MECKLENBURG COUNTY HEALTH DEPARTMENT

APPLICATION FOR PERCOLATION TEST

SITE EVALUATION

SITE INVESTIGATION REPORT
INDIVIDUAL SEPTIC TANK SYSTEM
WITH SUBSURFACE,
SOIL ABSORPTION,
EFFLUENT DISCHARGE

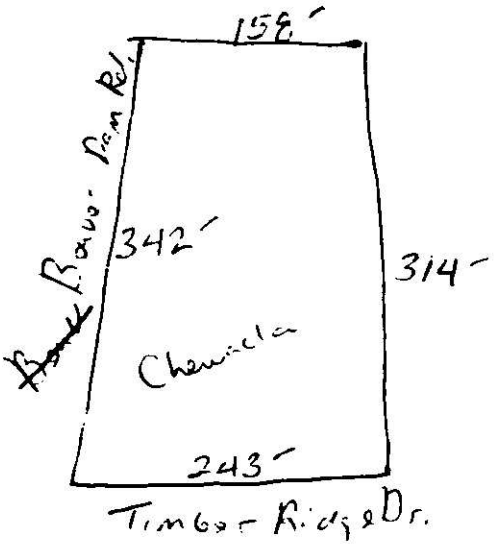
FACTORS	AREA 1	AREA 2	AREA 3	AREA 4
1. [illegible]	S PS U —	S PS U	S PS U	S PS U
2. [illegible] (12-36 in.) [illegible], loamy, clayey, [illegible])	S PS U —	S PS U	S PS U	S PS U
3. SOIL STRUCTURE (12-36 in.) [illegible] soils)	S PS U —	S PS U	S PS U	S PS U
4. [illegible] DEPTH (In.)	S PS U —	S PS U	S PS U	S PS U
5. RESTRICTIVE HORIZONS (In.) (Impervious Strata, rock)	S PS U —	S PS U	S PS U	S PS U
6. SOIL DRAINAGE (GROUNDWATER (External & Internal)	S PS U poorly drained	S PS U	S PS U	S PS U
7. SOIL PERMEABILITY (Percolation Rate)	S PS U [illegible]	S PS U	S PS U	S PS U
8. OTHER (Specify)	S PS U [illegible]	S PS U	S PS U	S PS U
9. SITE CLASSIFICATION*	Unsuitable			
SOIL SERIES	Chewacla

Recommendations/Comments: Based on this investigation, the lot was found to have soils generally unsuitable for installation of a septic tank system.
